ADDENDUM NO. 3

Wayne High School Campus Improvements

Fort Wayne Community Schools (FWCS)

November 14, 2025

1. Plan Sheet C2.5 – Site Dimensional Plan – Zone E

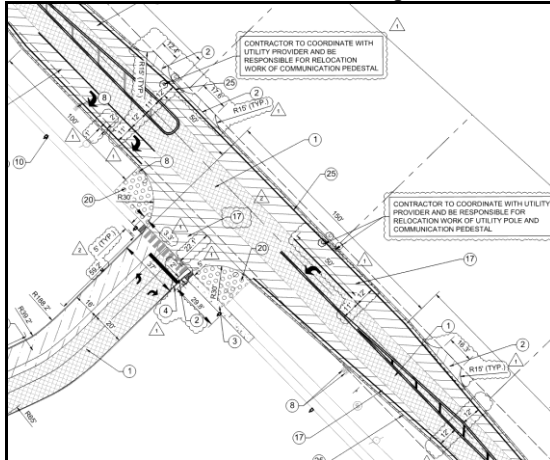
REVISED: Keynote #2 on entrance drive to keynote #17.

ADDED: Dimension for curb end tapers.

2. Plan Sheet C2.8 – Pavement Marking Plan – Zone A

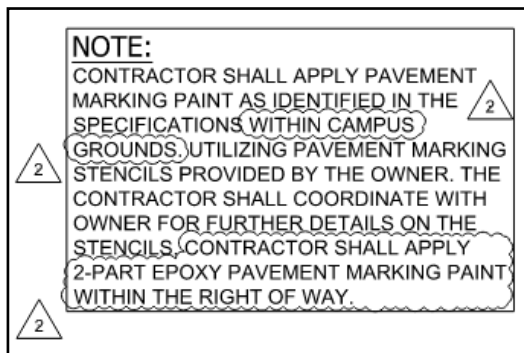
REVISED: Changed color on keynote #51 and #52 from “white” to “yellow”.

REVISED: Contractor note for pavement markings within the right of way to be 2-part epoxy paint.

5. Plan Sheet C2.11 – Pavement Marking Plan – Zone D

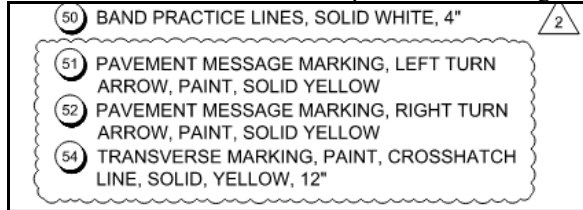
REVISED: Changed color on keynote #51 and #52 from “white” to “yellow”.

REVISED: Contractor note for pavement markings within the right of way to be 2-part epoxy paint.

7. Plan Sheet C3.2 – Site Grading Plan – Zone B

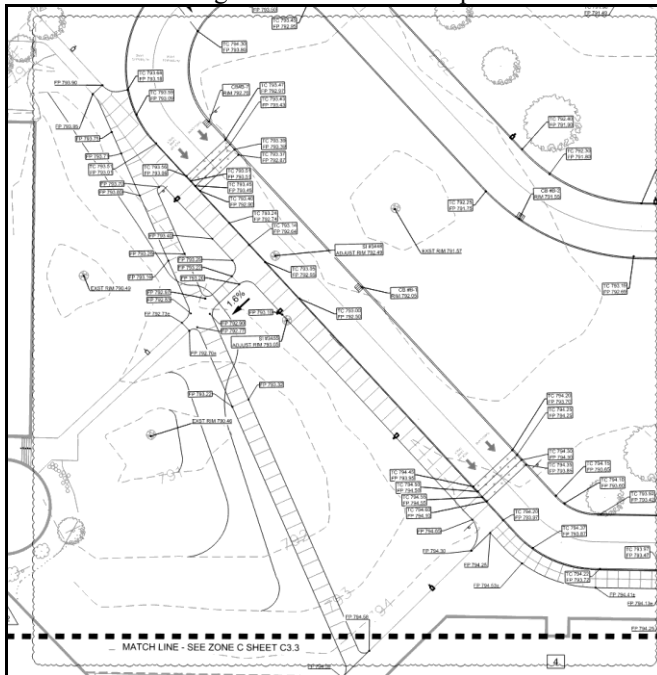
REVISED: Existing contours have been updated to reflect accurate existing conditions.

8. Plan Sheet C3.5 – Site Grading Plan – Zone E

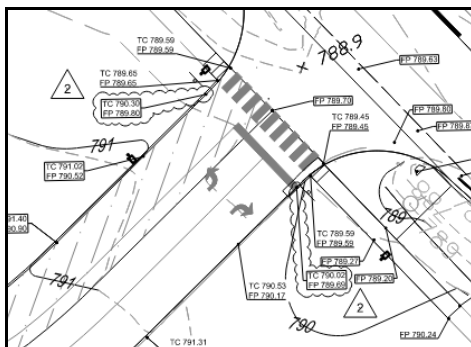
ADDED: Spot elevations added at curb end tapers.

9. Plan Sheet C3.7 – Site Grading Plan – Zone G

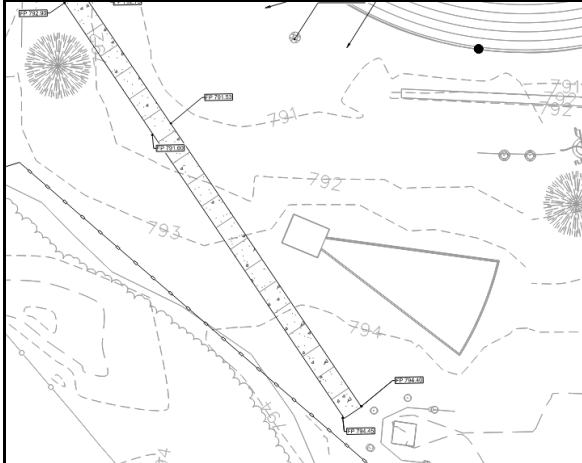
REVISED: Existing contours have been updated to reflect accurate existing conditions.

10. Plan Sheet C3.8 – Curb Ramp and Turn Lane Details

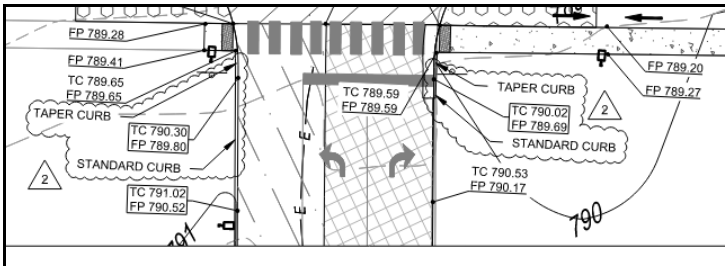
ADDED: Spot elevations and curb taper labels added.

11. Plan Sheet C8.1 – Site Details Sheet I

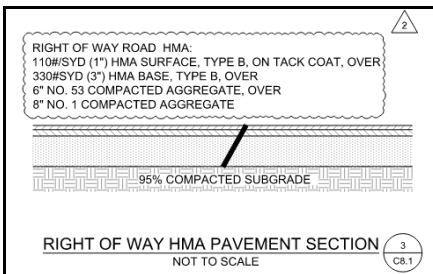
REVISED: Right of way HMA pavement section (3/C8.1) to match Allen County Highway Department standards.

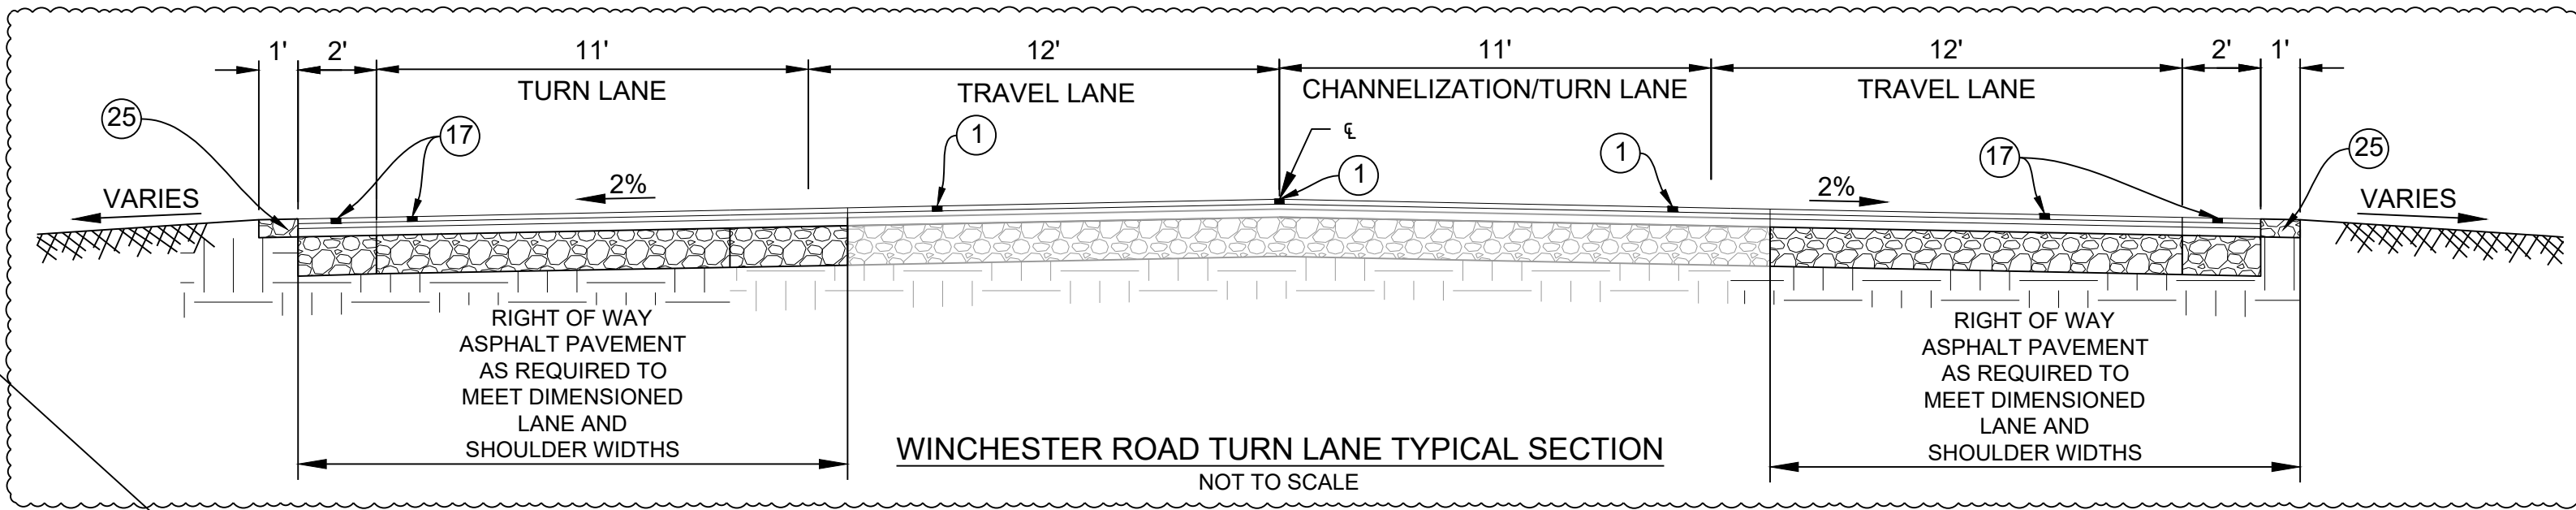
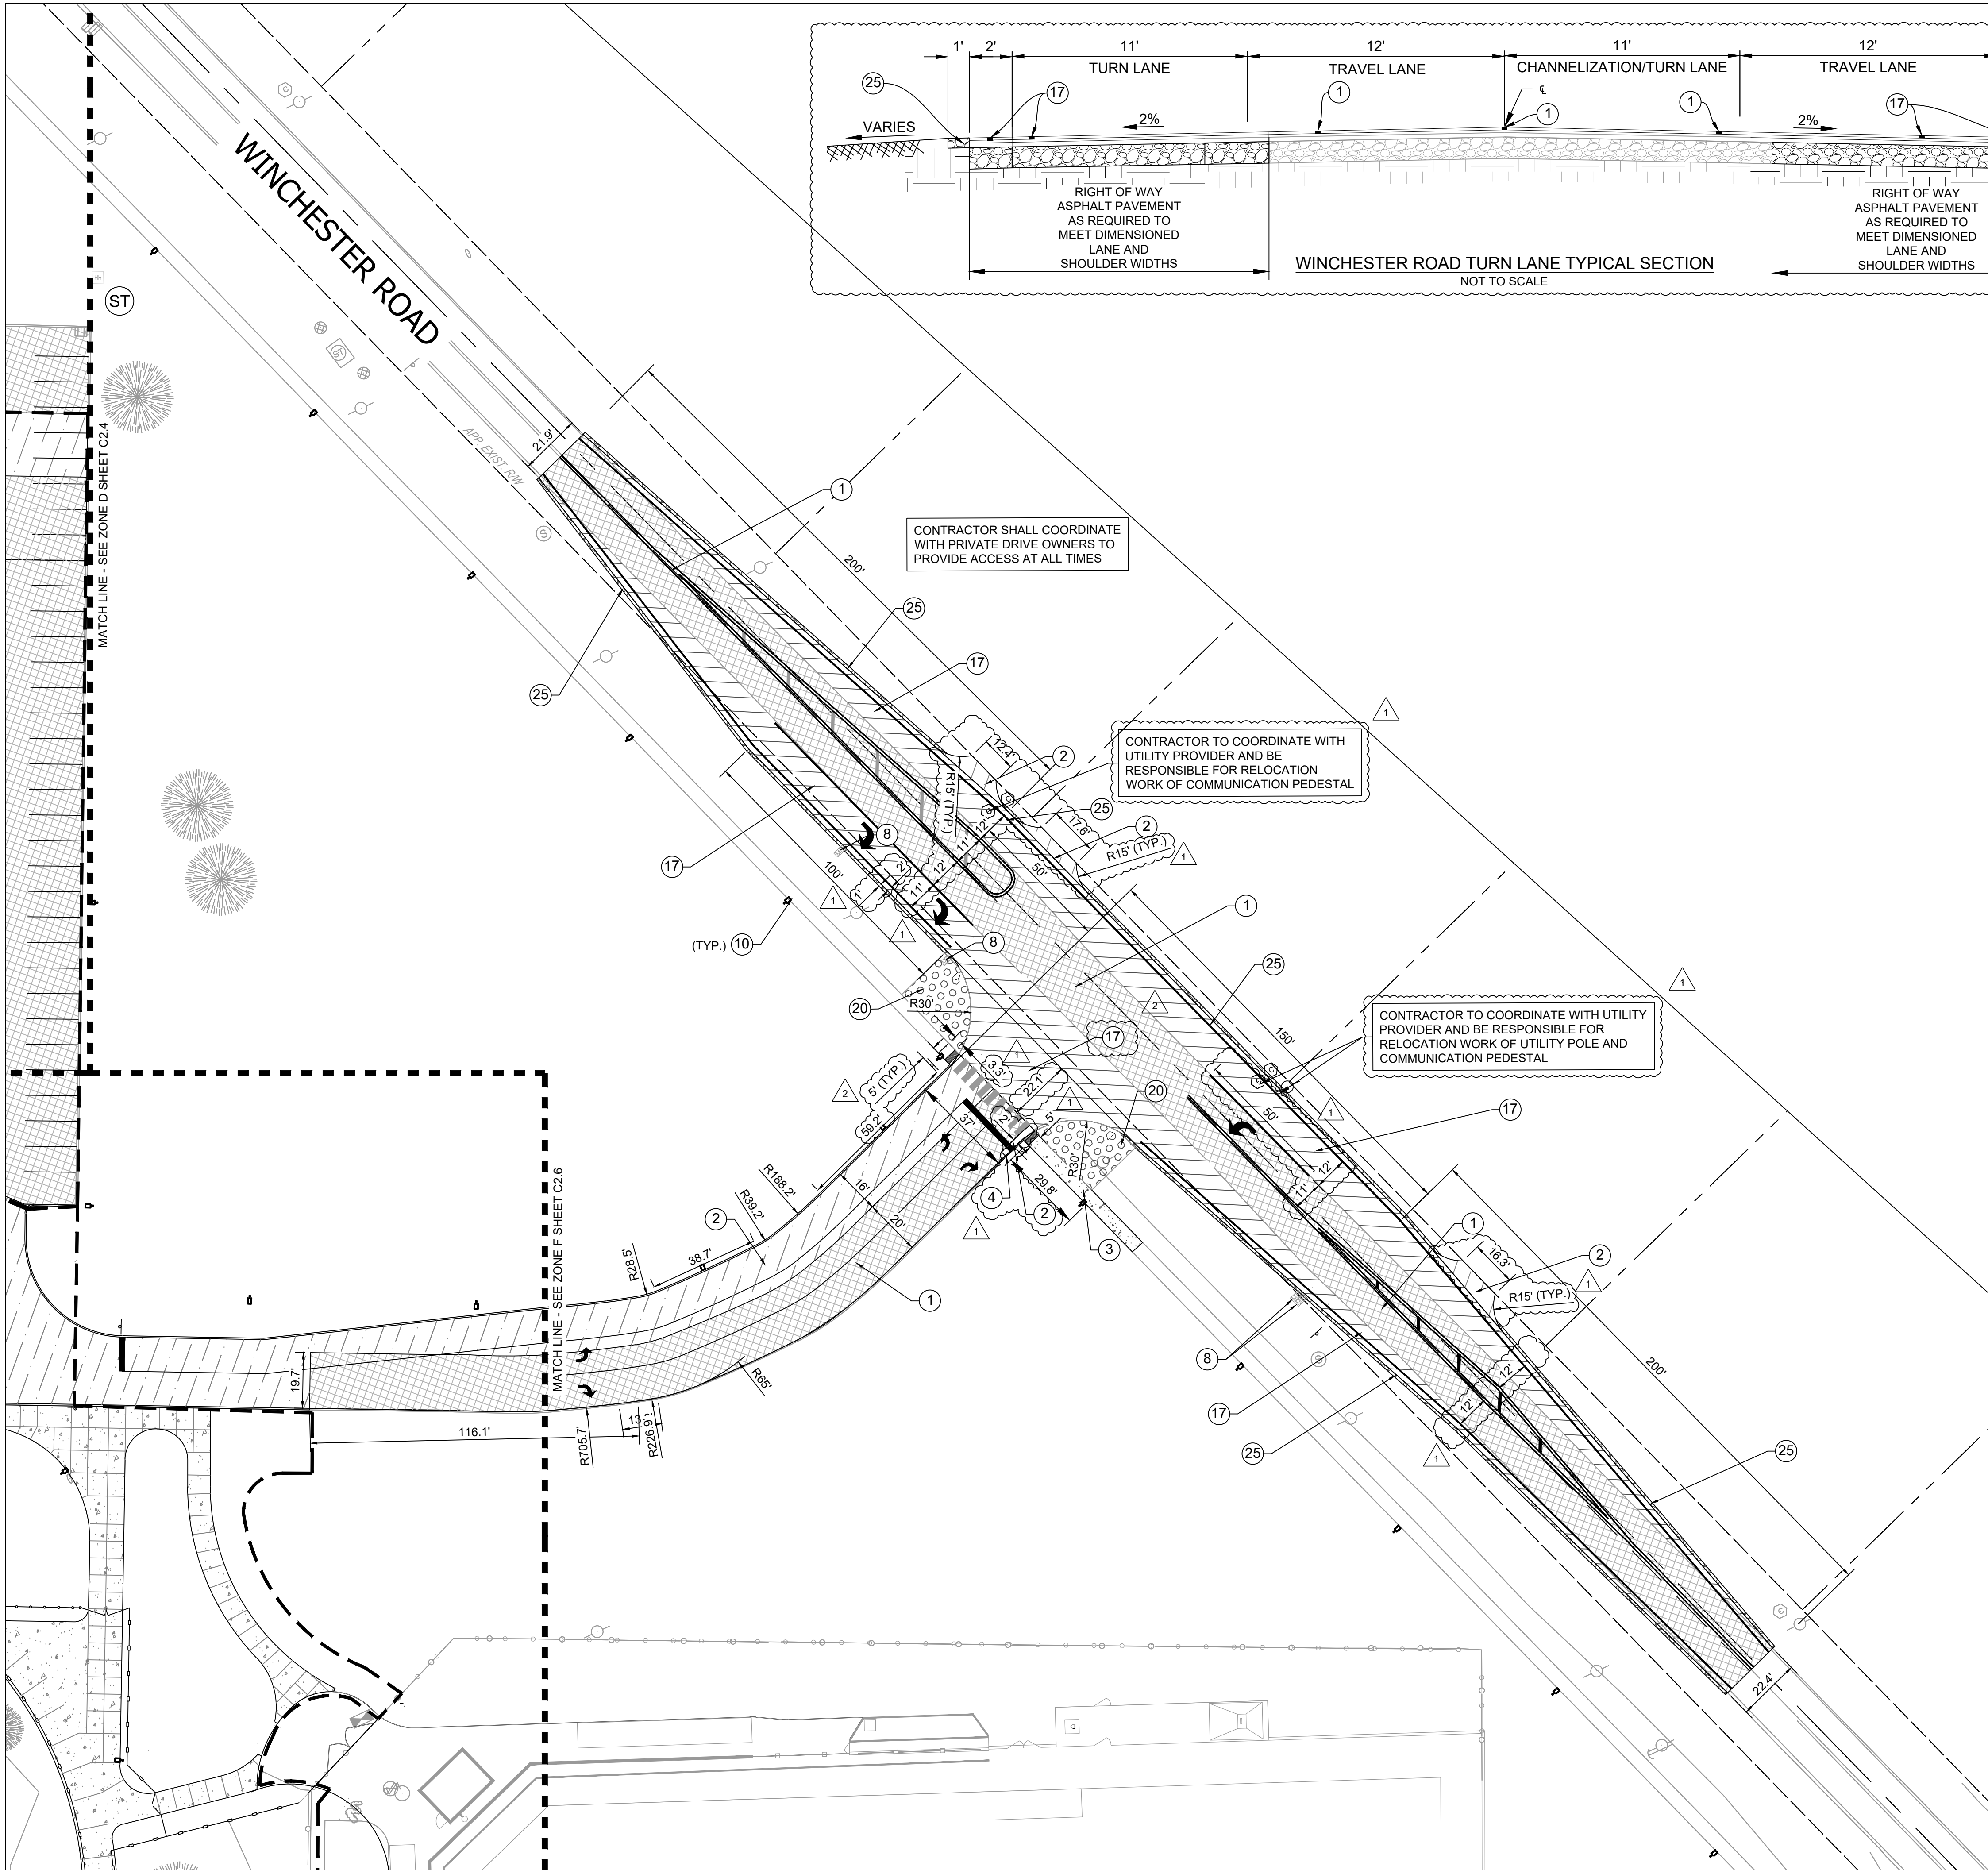
- a. Yes, CB#D-1, CB#D-2, and CB#D-3 along with associated storm piping and pavement replacement will be included in base bid.
3. *On sheet C2.5, the approach tying into Winchester Rd. is hatched as ROW Pavement but labeled “2” which is “Asphalt Parking Lot Pavement”. Is this intended to be ROW Pavement?*

- a. Yes, this approach is intended to be ROW pavement. This has been revised on sheet C2.5.
4. *On sheet C2.0A it states “PERIMETER FENCE IMPROVEMENTS A PART OF ALTERNATE #5”, but sheet C2.7 it appears the sidewalk area is all apart of the base bid, how is this fence to be installed as part of the alternate but the sidewalk that goes through the existing fence is part of the base bid?*

1 ENLARGED TICKET BOOTH - TECHNOLOGY

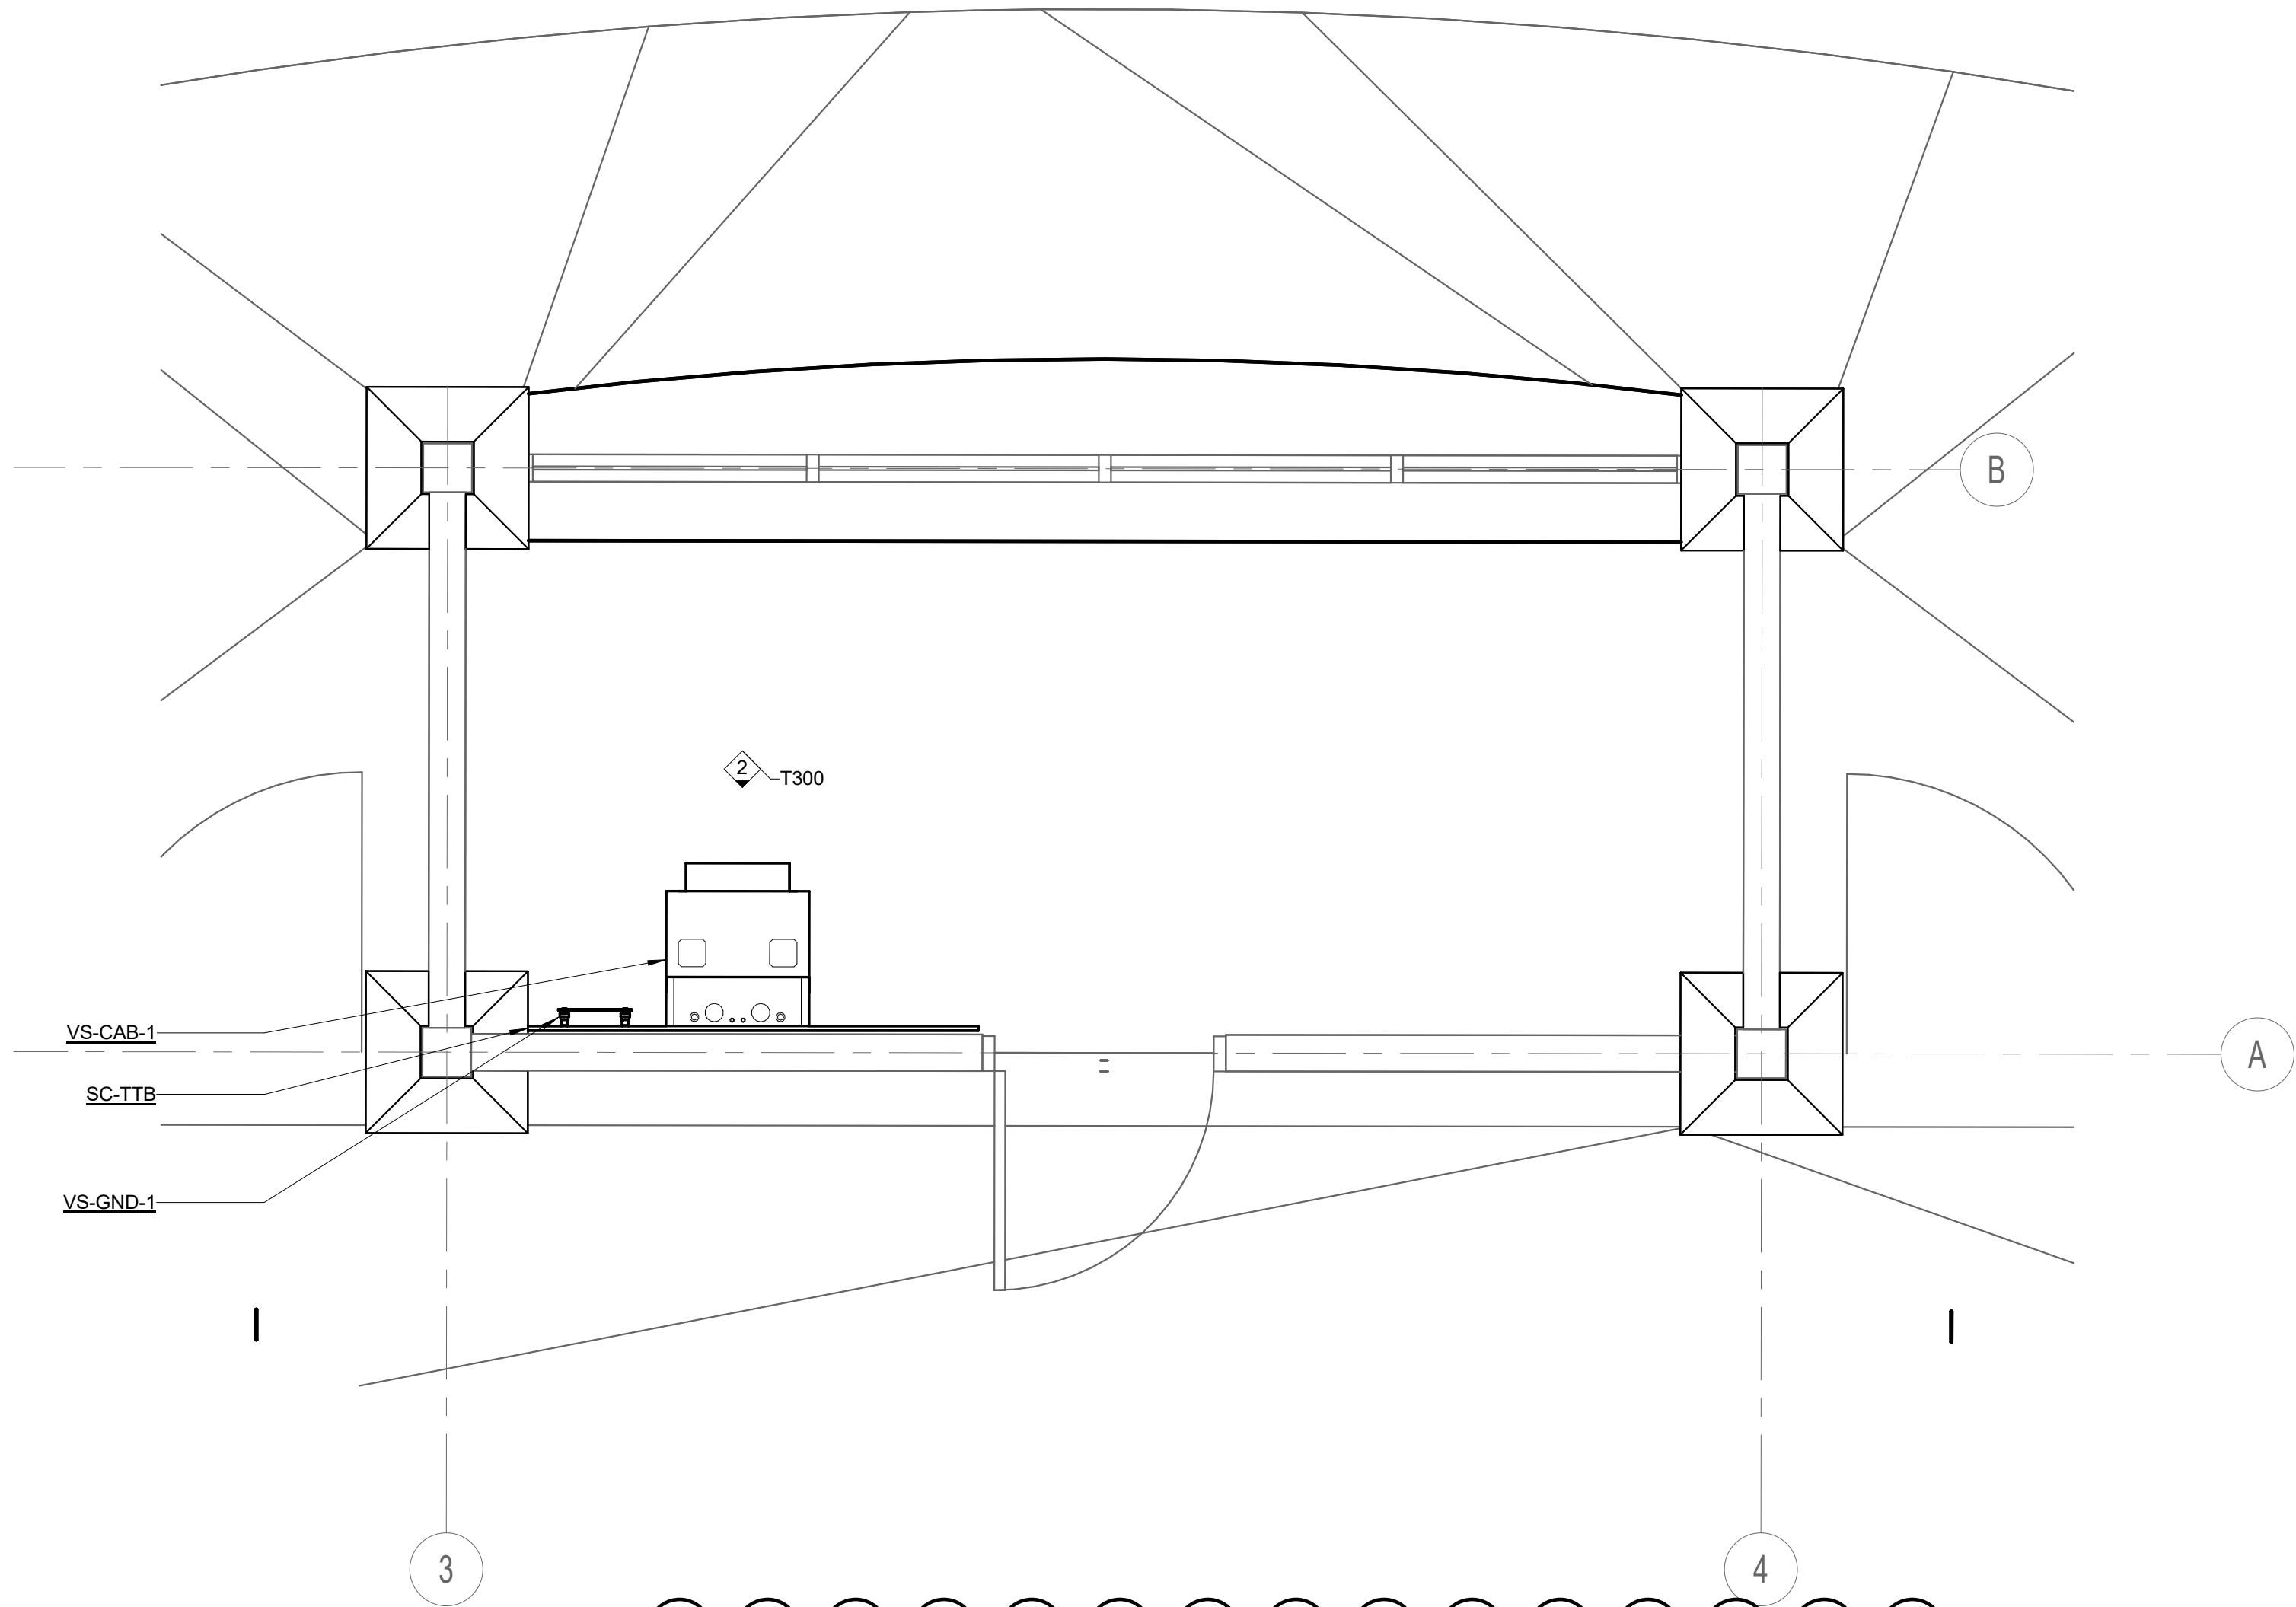
- a. SECTION 084313 has been revised and included in this addendum.
- 7. *What fiber will need to be installed from existing handhole to ticket booth? Is this supposed to be a 6 strand OS2 SM? (T211F)*

- a. Refer to Addendum #3 information for clarification
